UNITED STATES PATENT AND TRADEMARK OFFICE

APPLICATION NO.	FILING DATE	FIRST NAMED INVENTOR	ATTORNEY DOCKET NO.	CONFIRMATION NO.
10/773,242	02/09/2004	Hong-Jik Doo	956-1001	7168
38209	7590	12/02/2005		
STANZIONE & KIM, LLP 919 18TH STREET, N.W. SUITE 440 WASHINGTON, DC 20006			EXAMINER WILLIAMS, KENNETH C	
			ART UNIT 3739	PAPER NUMBER

Office Action Summary

DETAILED ACTION

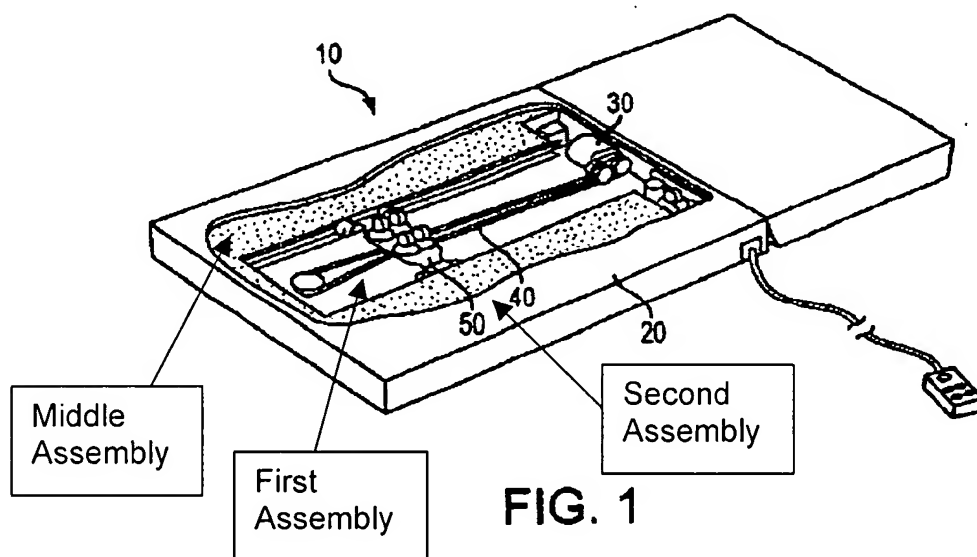
e. In regards to Claim 10, Kim discloses a personal thermotherapy instrument comprising first and second therapy components (See Kim Figure 3, elements 300 and 400; see also column 3, lines 19-35). Kim does not disclose "a folding part and first and second frames rotatably connected to the folding part and moving between a folding state and an unfolded state with respect to the folding part". Attention is directed to the Lloyd reference which provides a pertinent solution to providing a portable therapy table, discloses a collapsible frame containing first and second frames (See Lloyd Figure 1, elements 22 and 24; see also column 2, lines 28-38). It would have been obvious to one of ordinary skill in the art at the time of the invention to modify the device of Kim with the teaching of Lloyd to provide an easily storable thermotherapy instrument.

f. In regards to Claim 11, Kim in view of Lloyd discloses a personal thermotherapy instrument (See Claim 10 Rejection). Kim further discloses, "the

first and second therapy component are a spinal corrector and a foot pressure plate" (See Kim Figure 3, elements 300 and 400; see also column 3, lines 19-35).

FIG. 6a

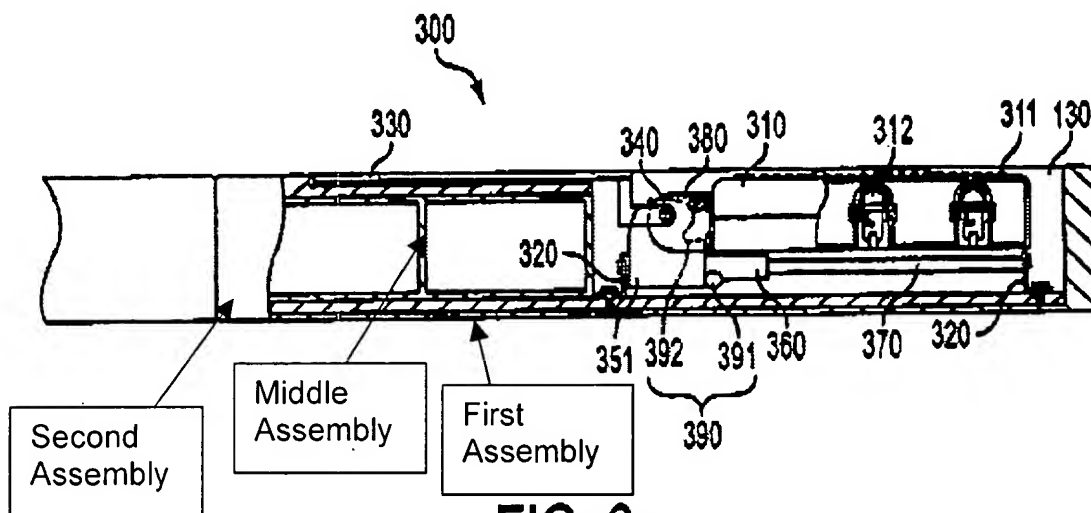
In regards to Claim 3, Kim in view of Lloyd discloses a personal thermotherapy instrument (See Claim 2 Rejection). Kim further discloses "first assemblies having a base plate", "middle assemblies each provided with electric field parts to cover the spinal corrector and the foot pressure plate" and "second assemblies combined as one body with an upper part of the middle assemblies" (See below Kim Figures 1 and 6a).

FIG 2

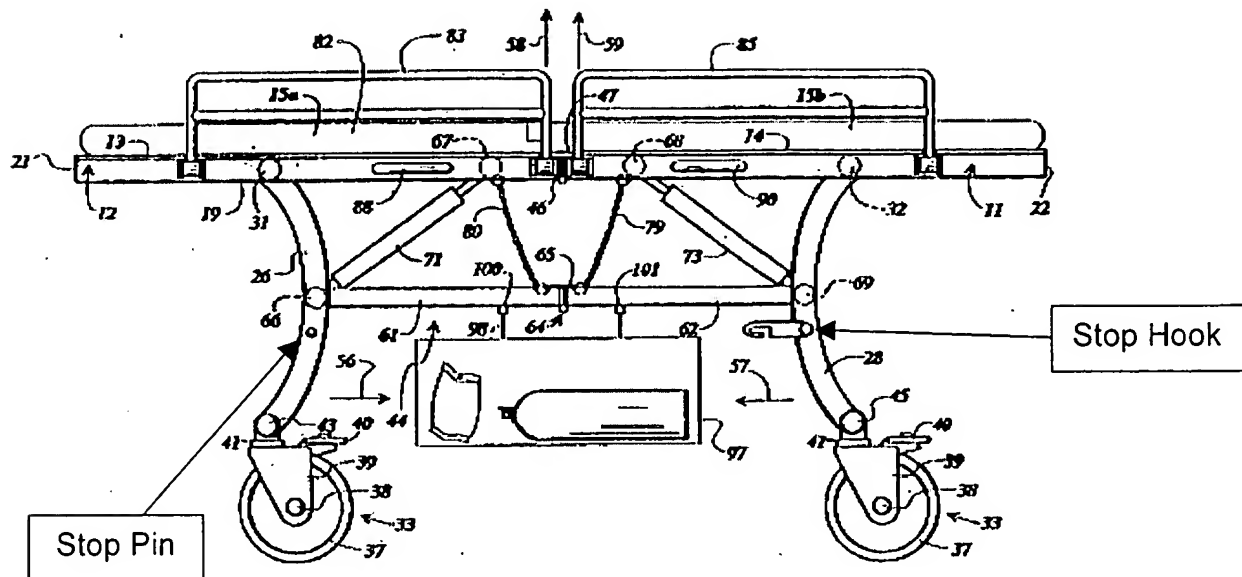
a. In regards to Claim 6, Kim in view of Lloyd discloses a thermotherapy instrument (See Claim 4 Rejection). Kim in view of Lloyd does not disclose “a stop pin” and “a stop hook”. Attention is directed to the Grant reference, which provides a pertinent solution to providing a portable therapy table, discloses a pin and hook lock on a collapsible patient bed (See below Grant Figure 2). It would have been obvious to one of ordinary skill in the art at the time of the invention to modify the device of Kim in view of Lloyd with the teaching of Grant to provide an adequate locking means to prevent unintentional unfolding the thermotherapy instrument.
